Technical Bulletin

Diagnosing Discharged Battery

9402

968 from Model Year 1992-on
911 Carrera 2/4 1989-1994 and 911 Turbo 1991-on

Figure 1

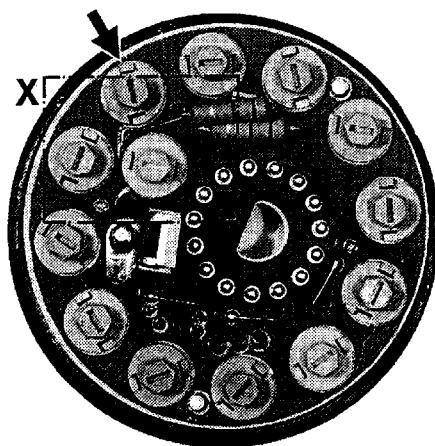
IMPORTANT NOTE: Procedure: 911 Carrera 2/4 from 1989 to 1993 model years, the current draw can be 26mA or slightly higher. To reduce this current draw by approximately 10mA, proceed as follows:

Coupe Version – Remove the time clock then remove and discard the bulb socket from position #2 (Arrow in Figure 1).

Figure 2

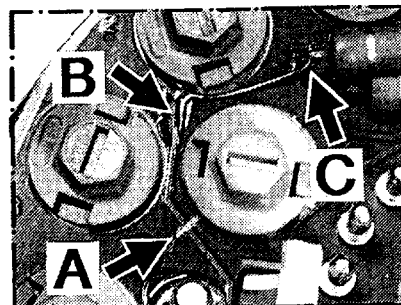
Cabriolet Version – The Cabriolet top warning light (socket #2) must be disconnected from terminal 30 and reconnected onto terminal 15. Proceed as follows:

- Remove the time clock.
- Break the connection from lamp socket #2 (Arrow "A," Figure 2).
- Remove the insulating coating on the current track at arrow "B" (Figure 2).
- Using a short length of wire, connect point "C" of resistor to point "B." Solder connections using a **low** wattage, small tip soldering pencil. Be certain no other connections are made or bridged.
- Reinstall time clock.
